ADDENDUM NO. 4

Moorpark College Parking Structure & Police Station

Project No. 10-555

Date: 08.31.2012

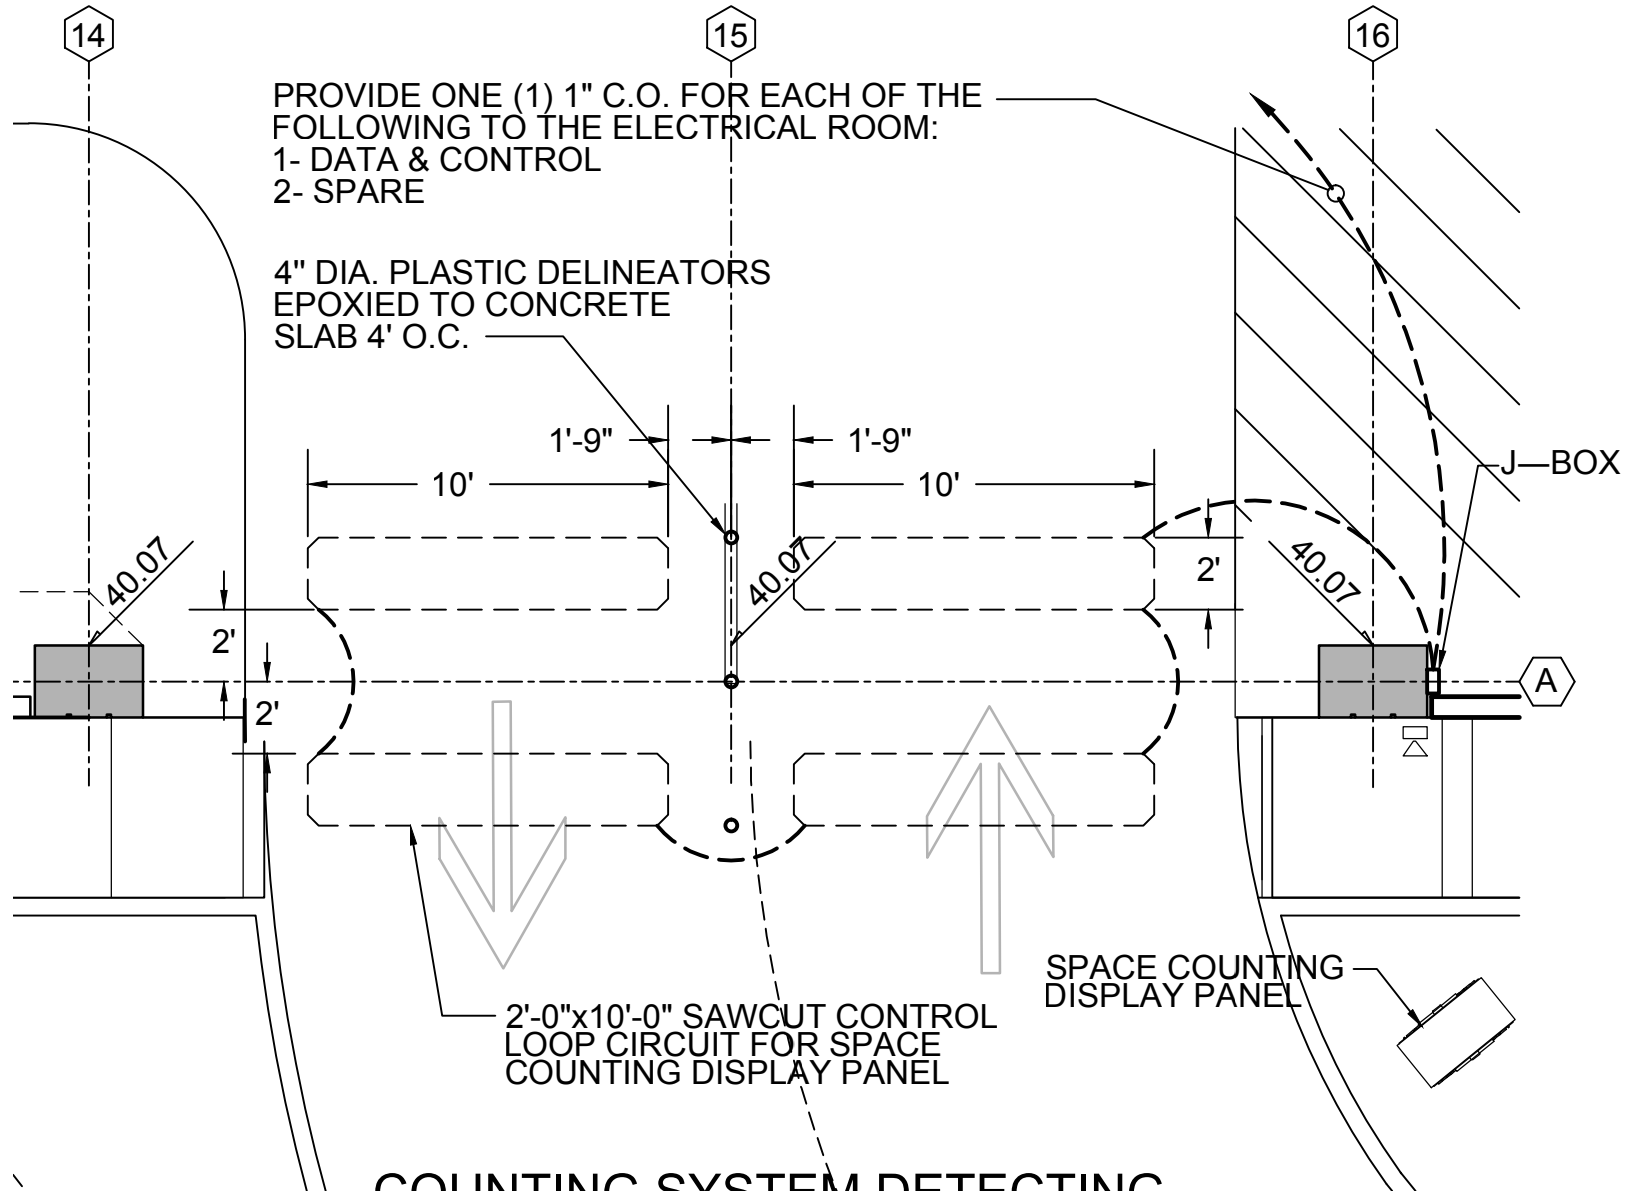
Q83- Per schedule, I found four (4) coiling doors. In the remark section, door # 1 & 3 are showing "...auto activated door" and on doors # 9 & 17, this wording is not there. Does this mean that they are "motorized"?

Q84- Also, all four doors show 1.5 hr fire rating on schedule, are they all, in fact, rated? The spec sheets show both rated and non-rated door spec's. Please advise.

A83- Yes, they are motorized.

A84- Doors 1, 2, 3 & 17 are rated doors.

Sk-A-001

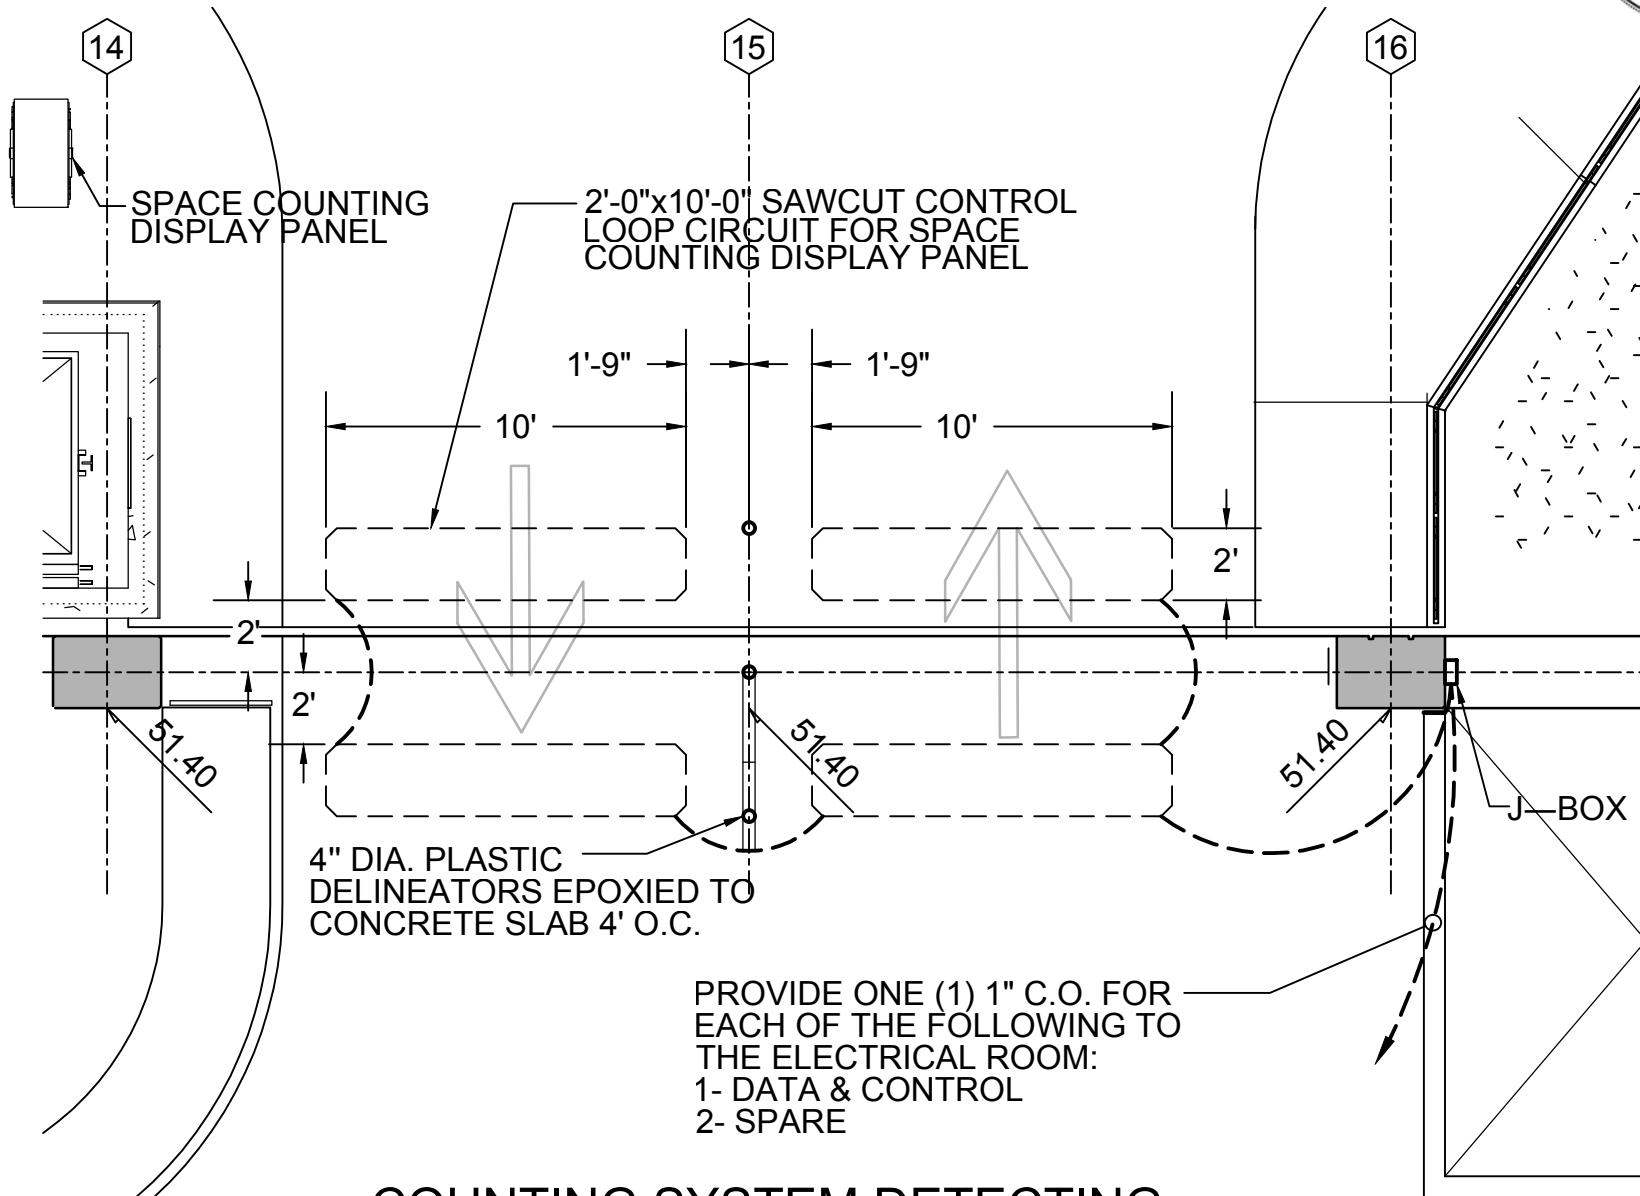
- A60- Refer to “Finish Schedule” – The call out on the east wall of the weapons room should read “WC1”.
- Q61- LOOP SENSOR – our parking consultant/Sub believes that if there is not a curb added to separate the “IN” from the “OUT” at the B1 level drive lane (See sheet A/2.01), that when the student drives into the parking structure too quickly on the “curve” in the road, the drives car tires may hit both the “IN” loop and the “OUT” loop... which will total mess up the entire counting system. Please add some sort of concrete curb along some portion of the entrance/exit drive way on Sheet A2.01

- A61- Provide three 4” dia. plastic delineators and 4 detection loops at each entry/exit. (See attached Sk-A-001 & Sk-A-002)
- Q62- SOLAR PANEL EMBED AT ROOF COLUMNS: Section 2/A6.03 indicates a call-out for “FUTURE” solar panels. Can you provide the detail of the embedded bolts and/or the base plate with or without grout for this future solar panel attachment. The bolts will have to be set now or drilled and epoxied later. If you decide on bolts now, can you provide the count of how many columns and which columns will get these bolt embeds. S2.04 also does not show the locations or the detail for “future” sola panel attachments.

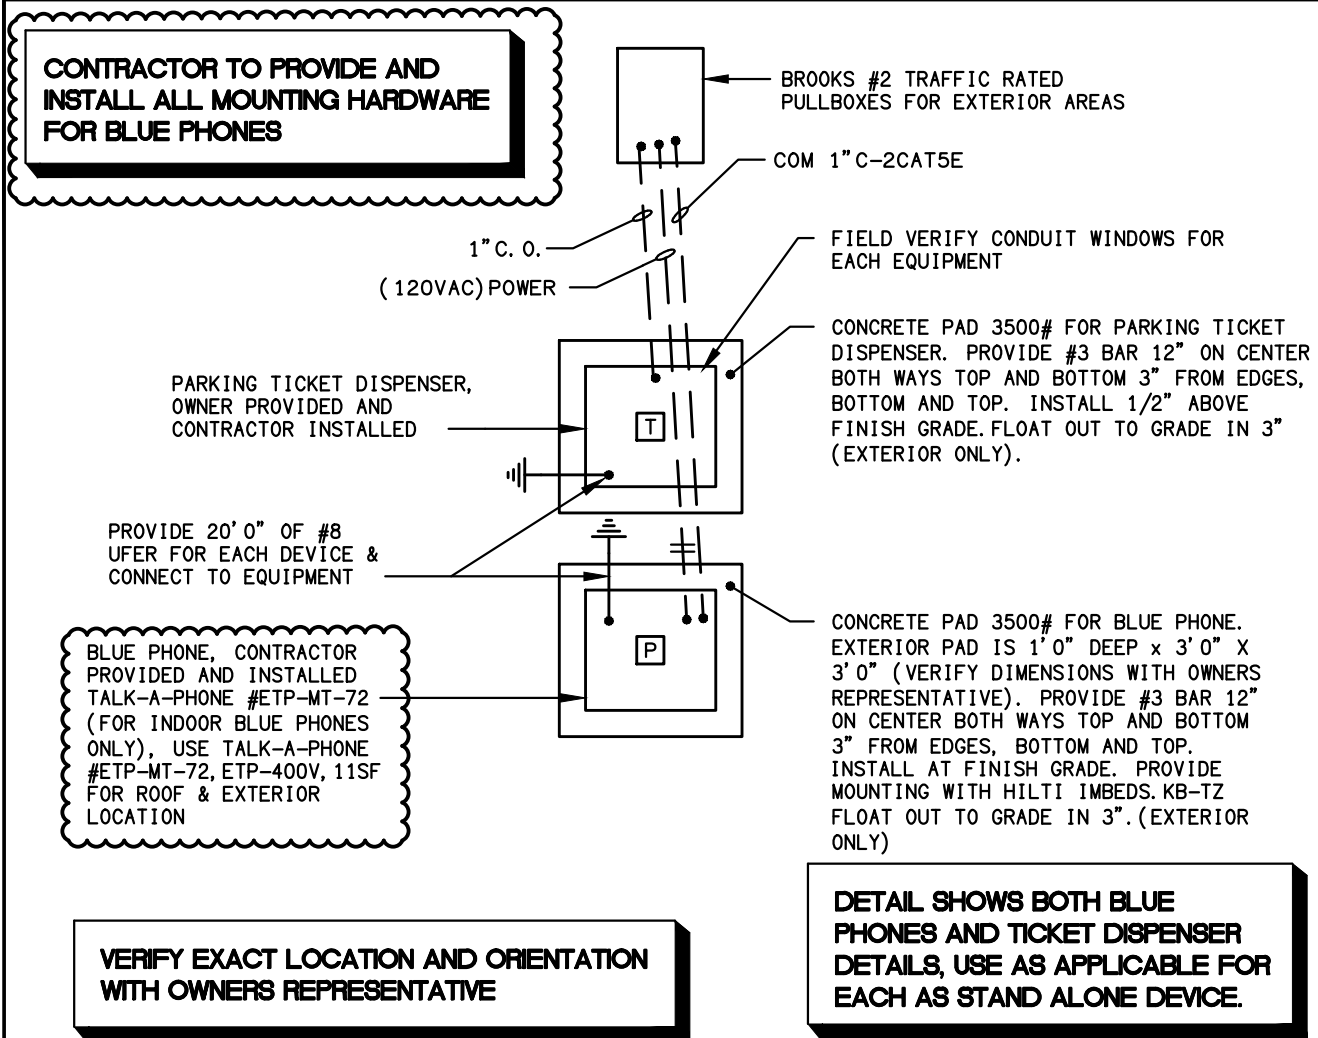
Provided sketch for clarification:

EQUIPMENT DETAIL

INSTALL PER
MANUFACTURERS
RECOMMENDATIONS
